Haddam Neck Plant
Additional Information - Steam Generator Water Hammer

ADDITIONAL INFORMATION - STEAM GENERATOR WATER HAMMER

NRC REQUEST FOR ADDITIONAL INFORMATION ON STEAM
GENERATOR WATER HAMMER

PRINTED IN U.S.A.

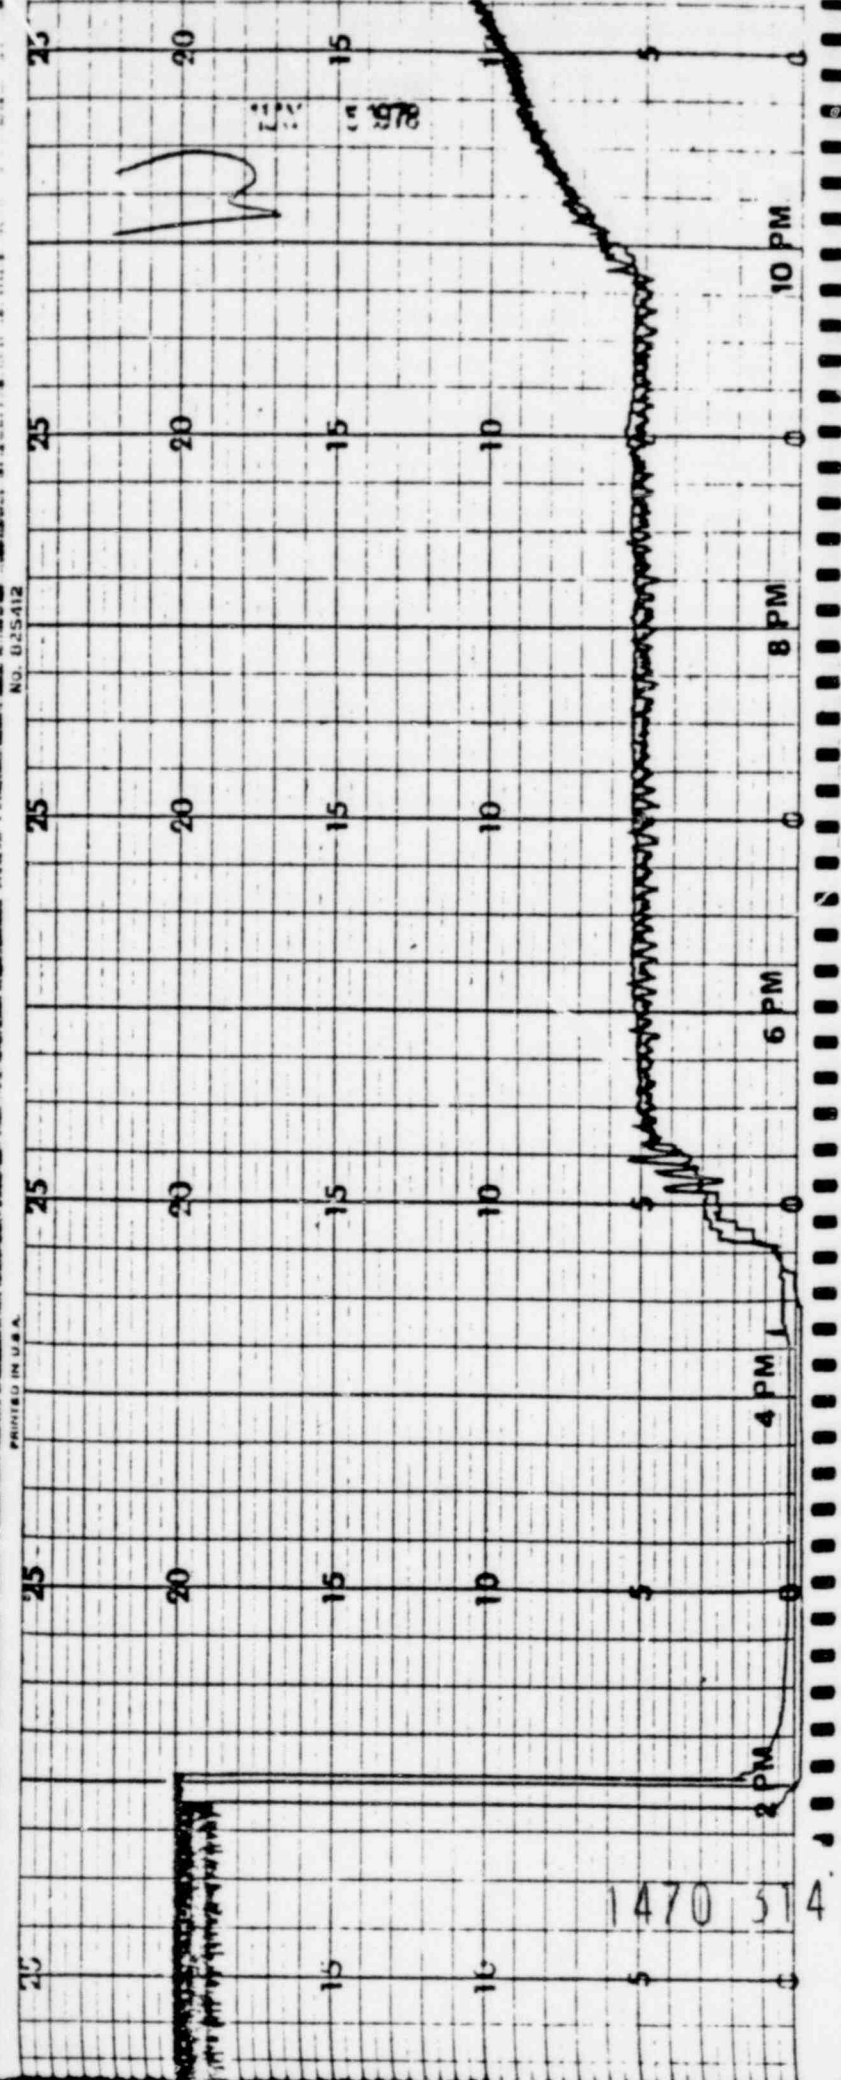
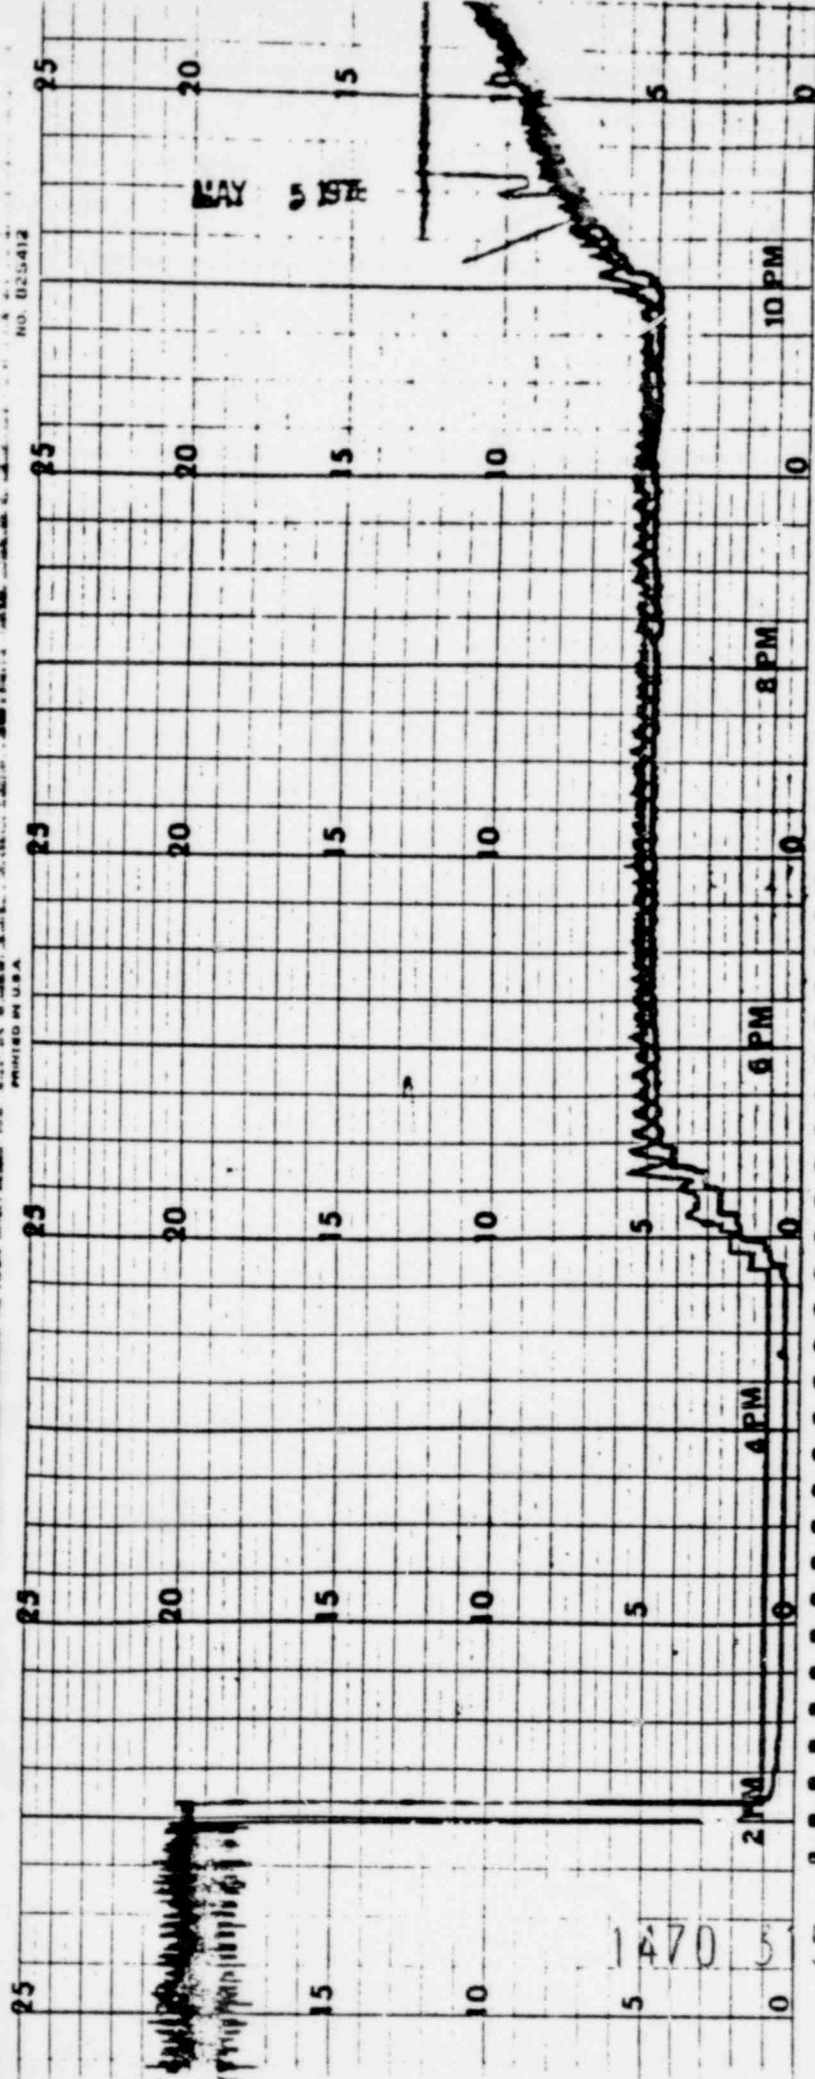
- 1.1 Describe the expected behavior of steam generator water level as a result of reactor trip from power levels greater than 30% of full power. Include actual plant measurements of steam generator level and other available data such as feedwater flow and auxiliary feedwater flow.

Actual plant measurements of a reactor trip which occurred from full power on May 5, 1978 are provided. This data represents the steam generator water level (narrow range 0-100%) and feedwater flow/steam flow (lbs/hr) for each steam generator. Feedwater bypass flow and

auxiliary feedwater flow are not available since they are not recorded. The data which is presented is representative of all reactor trips.
